Reference: Newton Street - 21 - Comprehensive Permit Chapter 40B - Zoning Board of Appeals - former Leland Home

RE: 21 Newton Street, 40B Comprehensive Permit Application  
Response to Fire Department

DRAFT FIRE EXHIBIT  
1/24/2022

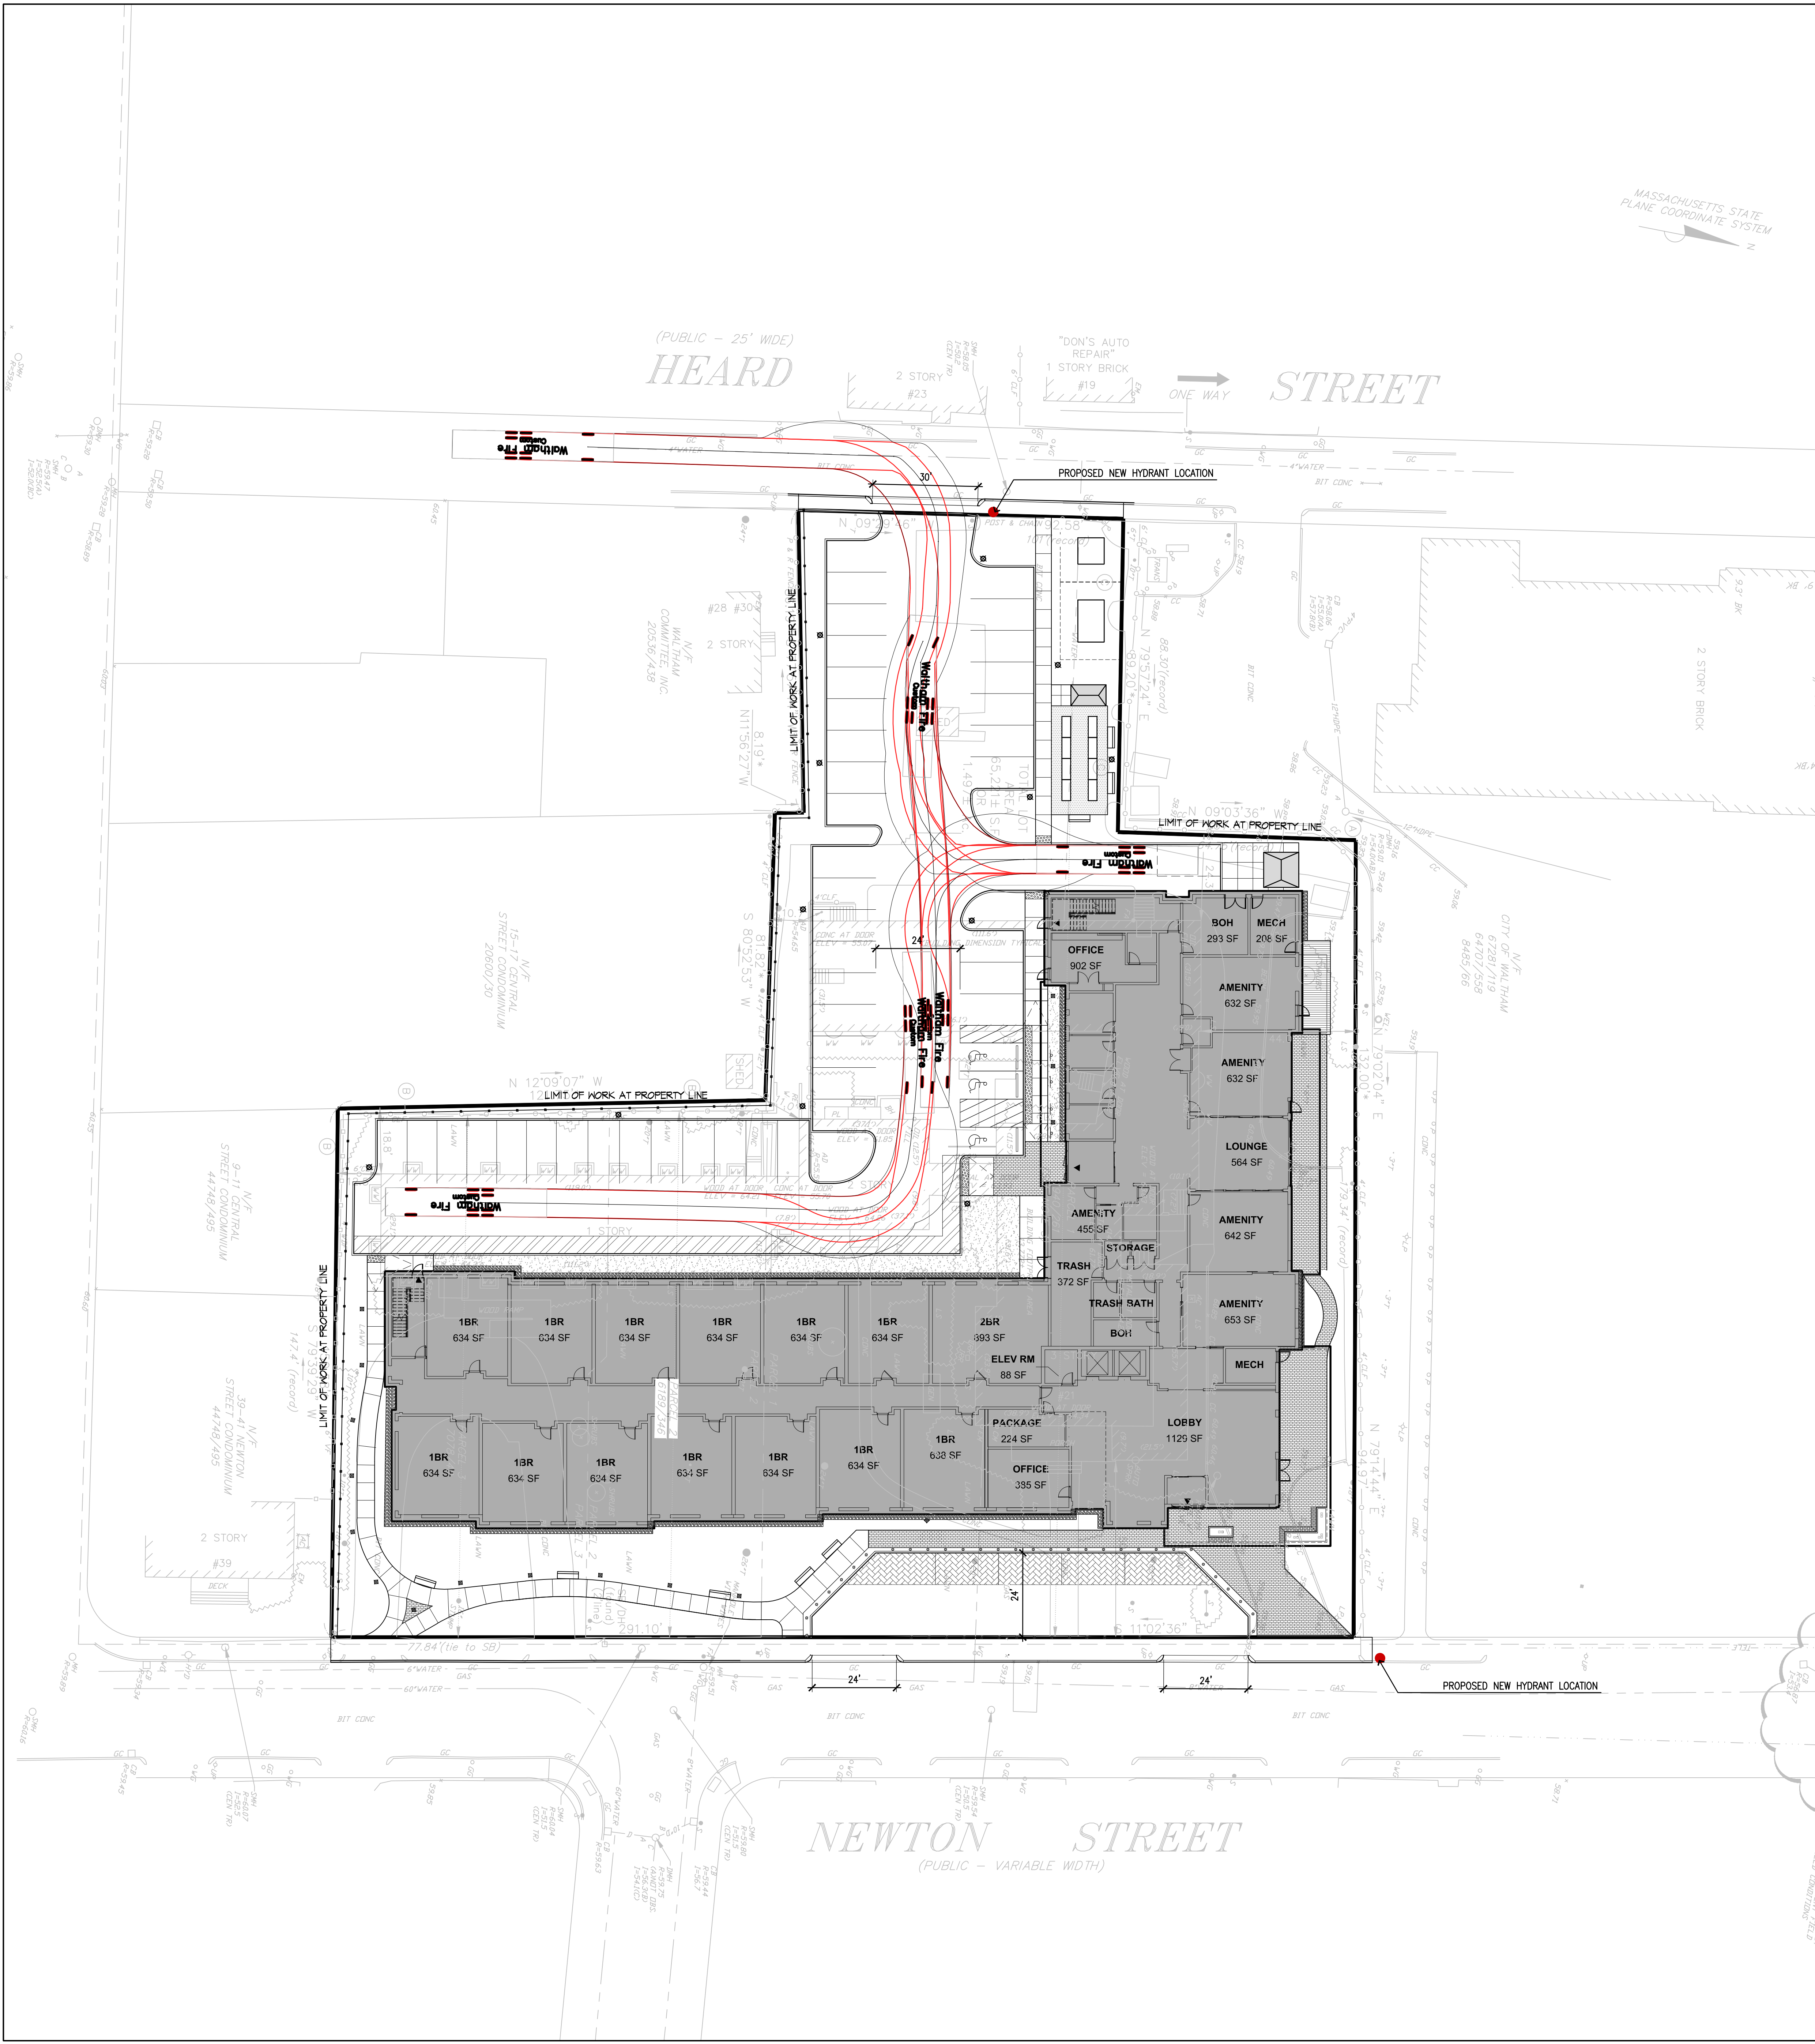
1. Front of building on Newton Street side- enlarge curb cuts from 20' to 24' to allow fire apparatus and/or ambulance to pull into driveway and avoid blocking traffic on Newton Street.

2. Front driveway- enlarge width of front driveway from 19' to 24' to allow fire apparatus and/or ambulance to bypass each other and/or civilian parked vehicles.

3. Rear entrance off Heard Street- enlarge curb cut from 24' to 30' to allow fire apparatus to enter the rear lot.

5. Rear driveway- enlarge width of parking area from 20' to 24' wide to allow apparatus to bypass each other if necessary.

6. Rear driveway- provide turnaround for fire apparatus in rear lot or continue fire access road around to connect with Newton Street on left side of building (B side).

7. Submit swept path analysis showing apparatus can safely enter the site and exit the site.

*Agreed. The two (2) curb cuts on Newton Street shall be enlarged to 24' on the Revised Plans to be filed with the Zoning Board of Appeals (ZBA) at a later date and as shown on the attached **Exhibit A – Fire Access Plan**.*

*Agreed. The width of the front driveway off of Newton Street shall be enlarged to 24' on the Revised Plans to be filed with the ZBA at a later date (see also **Exhibit A – Fire Access Plan**).*

*Agreed. The width of the Heard Street curb cut shall be enlarged to 30' on the Revised Plans to be filed with the ZBA at a later date (see also **Exhibit A – Fire Access Plan**). Further, the Petitioner shall modify its list of waivers to include a waiver from § 5.41 of the Zoning Ordinance with regard to a driveway opening exceeding 25'.*

*Agreed., The Heard Street driveway shall be enlarged to 24' on the Revised Plans to be filed with the ZBA at a later date (see also **Exhibit A – Fire Access Plan**).*

*Agreed. The rear parking lot has been redesigned to allow fire apparatus to reach the southerly wing of the building and then turn around in the rear lot by backing into the loading area, as can be seen on **Exhibit A**. Stantec is in continued discussions with the fire department to review the updated fire access plan and swept path analysis in person. However, it should be noted that creating a connection from the rear lot to Newton Street on the south side of the building would require a significant redesign of the building and site, loss of a number of housing units and parking spaces. The Leland House building was located in the best location on the site from an engineering and architectural perspective and based on an extensive community process with the Ward Councilor, neighbors and abutters that resulted in a significant reduction in size from the initial proposal before the Community Preservation Committee and the City Council. Redesign of the building included reduction of the building size from 79 units to 68 units, lowered height from 4 stories to 3 stories, and an increase in the parking ratio from 40 spaces (0.5 ration) to 51 spaces (0.75). Further redesign of the building at this stage resulting in a loss of units could jeopardize the Petitioner's funding application with the Department of Housing and Community Development as part of its annual funding competition for affordable housing developments.*

*Agreed. Stantec has completed a swept path analysis and will be making an appointment with the Fire Department to review in person.*
